Progress Report
Third Quarter 2008 – July 1st to September 30th
Midwest Roadside Safety Facility
Midwest State's Regional Pooled Fund Program
September 15, 2008

Pooled Fund Consulting Summary

Figure 2. MWRSF PCB Metric Reinforcement Schematic

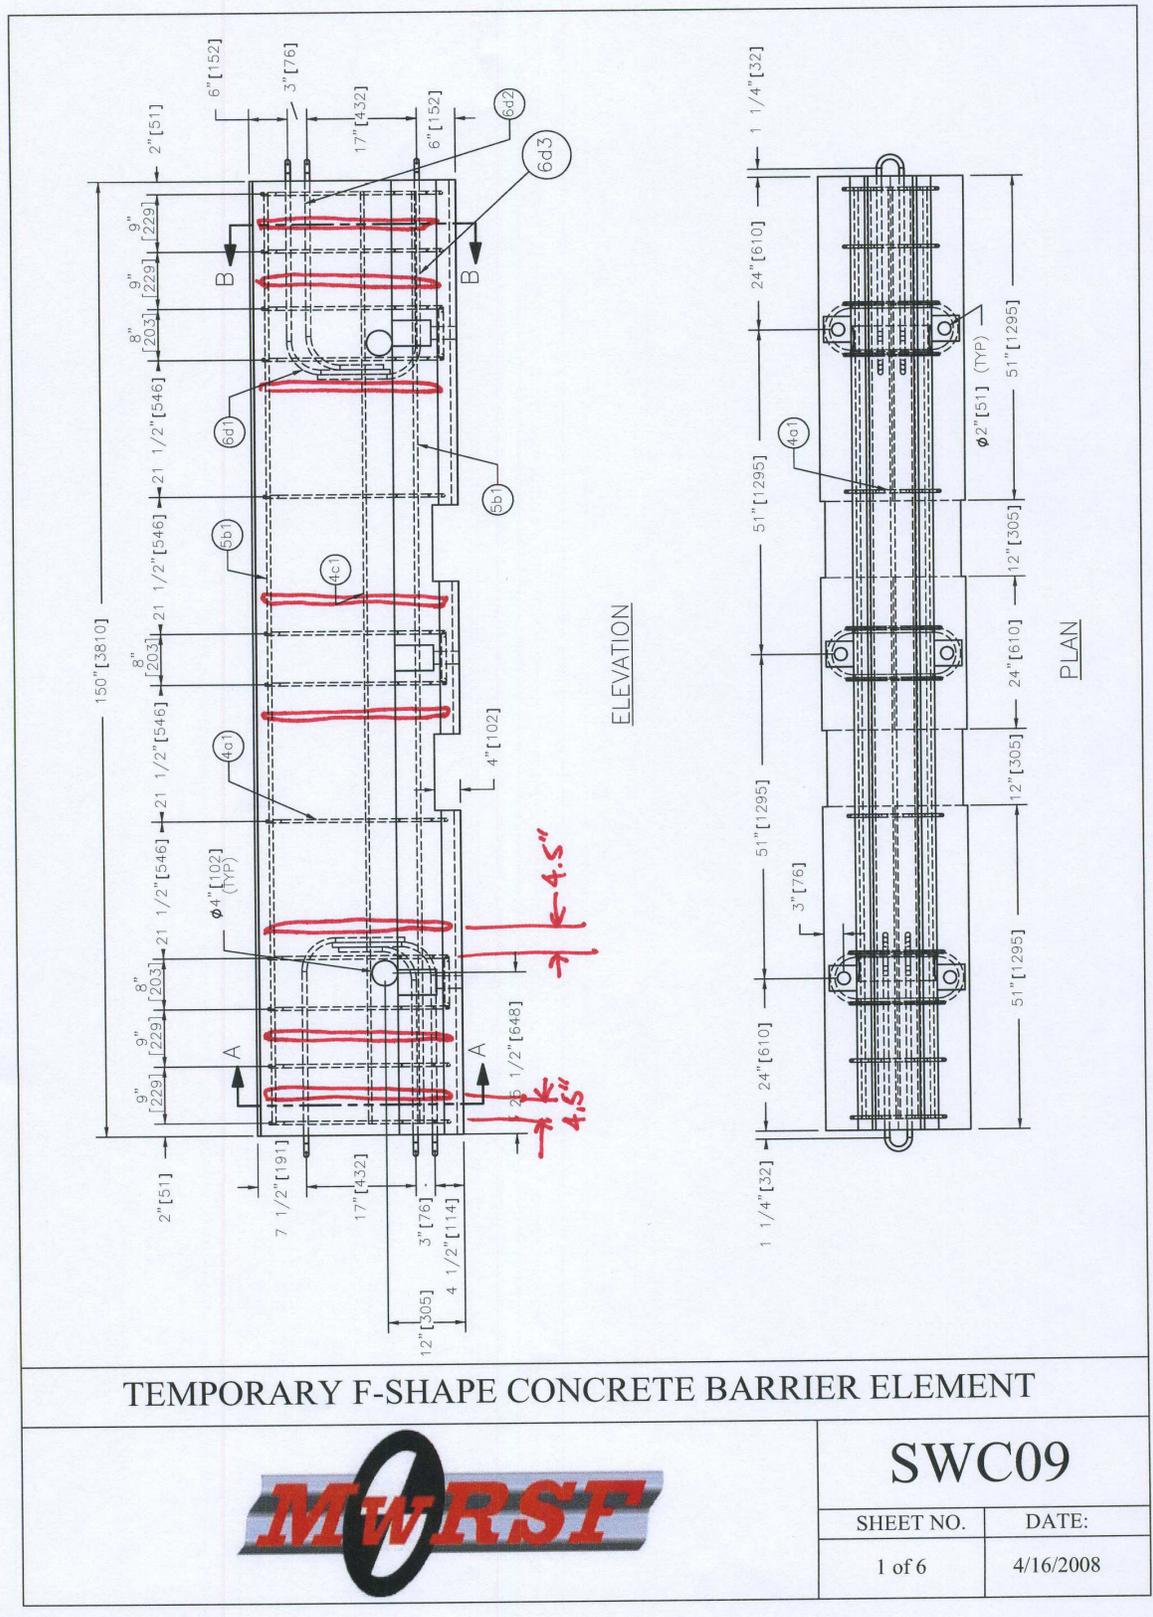
My first set of questions is with respect to rebar. In Canada we use metric rebar which is different from US metric or US customary. Our standard rebar is Grade 400 rebar which has a min yield strength of 400MPa and a min tensile strength of 600MPa. I understand an ASTM A615M Grade 420 bar has a minimum yield strength of 420MPa. Will this be a concern for the PCB?

The next metric problem I have is our sizes are different. Your #4, #5 and #6 bars have nominal diameters of 12.7mm, 15.875mm and 19.05mm respectively. Our standard 10M, 15M and 20M metric bars have nominal diameters of 11.3mm, 16.0mm and 19.5mm respectively. Originally we were going to specify 15M bars throughout, including the loop bars which is discussed below. For the #4 stirrups, we would like to now consider using the slightly smaller 10M bars unless you have a real concern.

For the loop bars, you have specified different steel – #6 smooth A706 Grade 420 steel. What is the rationale for using the larger diameter low alloy non-deformed steel bars for the loops ? Is it for welding or other reasons? Would you have a concern with our Grade 400 deformed 15M bars

The US rebar standard is Grade 60 which has a 60 ksi yield. This converts to a 414 MPA. The difference in strength is negligible, so I would not be concerned about the grade.

With regard to the bar size, it appears that your 15M and 20M bars have larger diameters than our No.5 and No. 6 bars. However, the US No. 4 bar has a diameter of 0.5" while your 10M bars have a 0.445" diameter. That is a 21% reduction in area. We would not recommend using bars with that much of a reduction in area. Thus, we would recommend that you substitute your 15M bars in locations where you are currently using the 10M bars. We believe this is necessary based on the amount of damage we have observed these barriers having during full-scale testing. We believe that the current barrier reinforcement is approaching its safe minimum capacity, so we have been holding the line and making alternative designs be equally as strong or stronger than the tested barrier configuration.

We would recommend that you use the 15M bars for the stirrups as well, but that may not be practical. If you have to use the 10M bars for the stirrups, we would recommend that you install additional 10M stirrups 4.5" from the each stirrup adjacent to the tie-down anchor pockets as well as an additional stirrup between the two stirrups on the end of each rail. See the attached sketch.

The loop bar steel is a different spec because we have found that the small bend diameter can cause reduced ductility and toughness in some grades of steel which compromises the impact strength of the loop. As such, we current specify that the loop steel must have a minimum yield strength of 60ksi, a minimum tensile strength of 80 ksi or 1.25 times the yield strength – whichever is higher, and a minimum % elongation of 14%. A706 and A709 steel both meet that spec. Others may as well. The bars can be deformed or smooth as long as the steel is within spec. Some of our states prefer smooth, so it is on the drawings that way. Again, we would recommend that you use the 20M bar because of the area difference between the No. 6 bar and the 15M bar (30% difference in area)

Figure 3. Tie-Down Through Asphalt Overlay Schematic

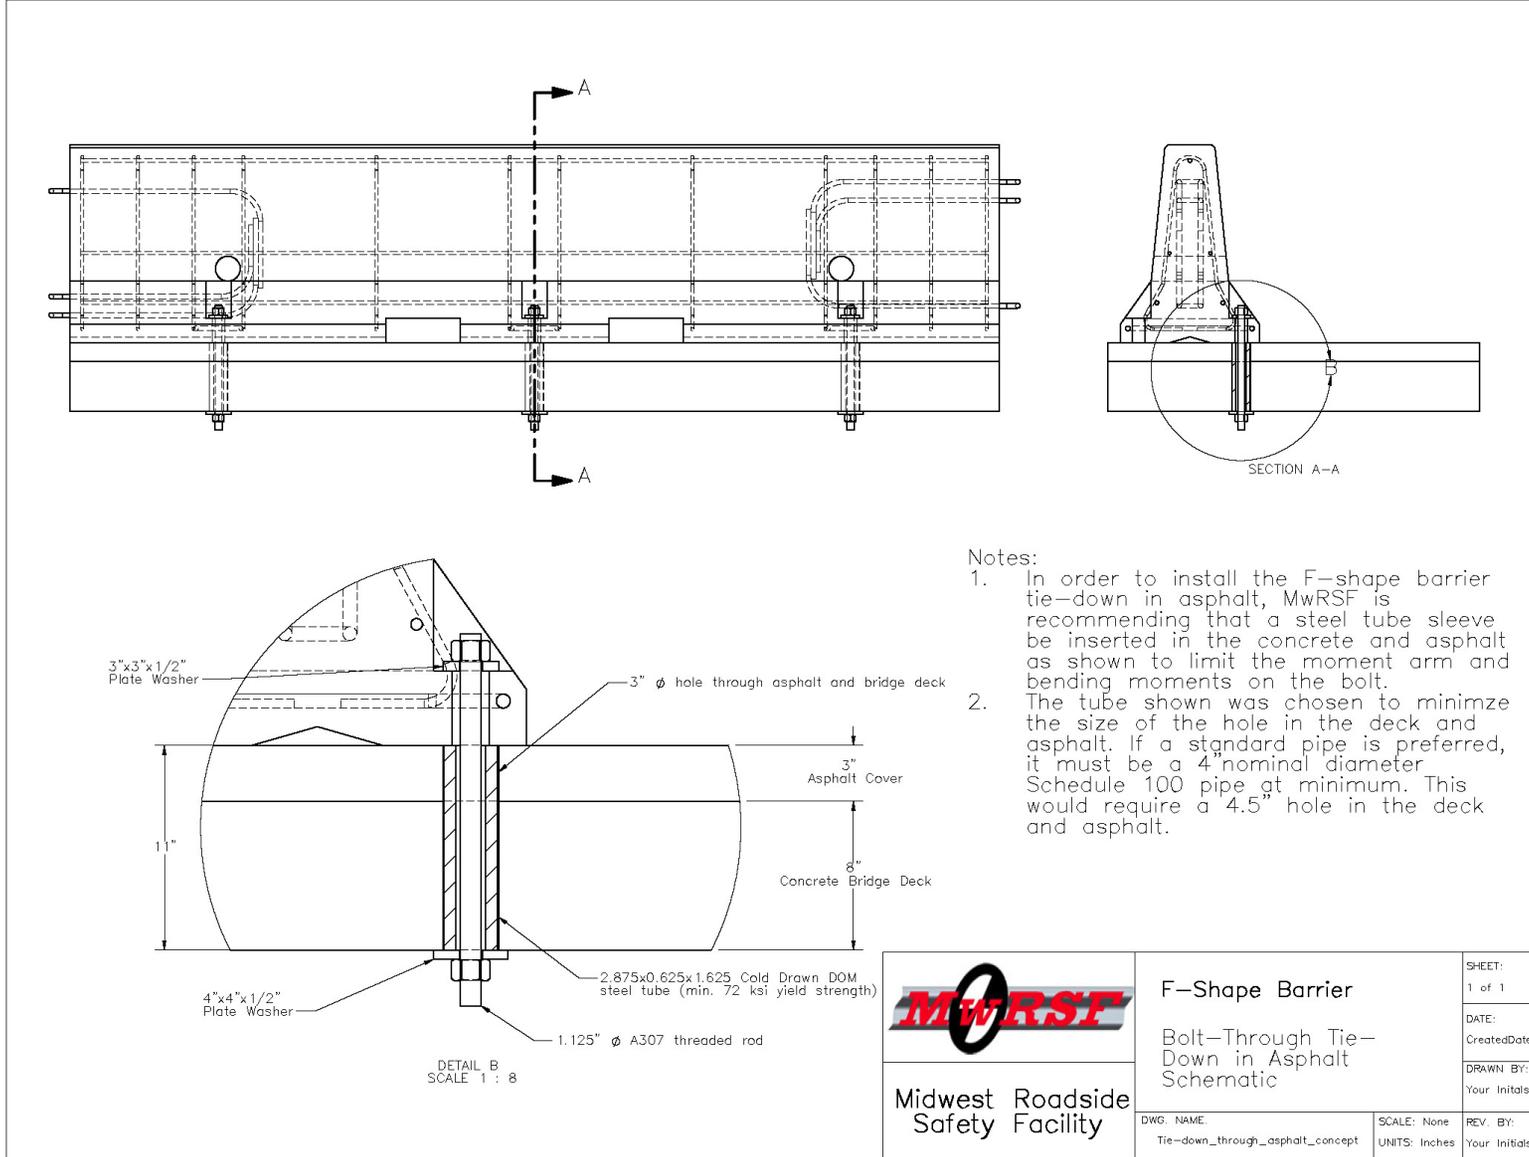
I was ask by a construction engineer, if it O.K. to bolt the 12.5-foot temporary concrete barrier to a bridge deck that has an asphalt overlay.

Currently, our detail (see attached) does not allow this. Why does the barrier need to rest on concrete? If there is an asphalt overlay on the bridge deck, is there some other modification to the design that we should do?

Our concern with installation the bolt-through tie-down in asphalt is that the asphalt increases the moment arm on the bolt and the corresponding bending stresses. We have come up with a retrofit using a pipe sleeve in the asphalt and concrete that should eliminate this issue. See the attached schematic.
